FIELD INSPECTION

Project Name:	Mountain Valley Pipeline	Inspector:	Matthew Grant
Inspection Date:	Wednesday, March 20, 2019	Project Contact:	Brian Clauto
Spread: Franklin County MP256-255 St1347-13496 MP261 St13818-13805	Spread I	Weather (Wet/Dry/Rain):	Dry

FIELD INSPECTION PHOTO LOG

▪ Fig. 1 St#13539+14 Slope lacks adequate stabilization

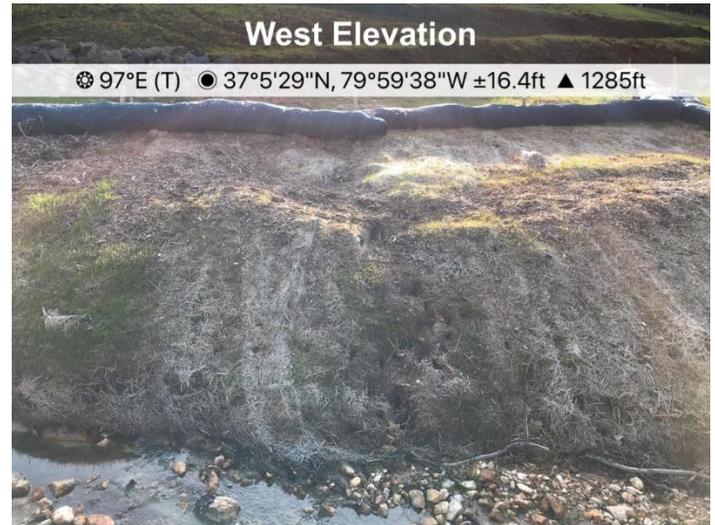
▪ Fig. 2 St#13533+52 Banks require repair and stabilization

▪ Fig. 3 St#13528+00 Rills at farmer road crossing and CFS requires maintenance

▪ Fig. 4 St#13500+00 Rill erosion along P1 SF and J-hook is overtopped

Recommended Corrective Action: Maintain all controls per the approved plan and specs.
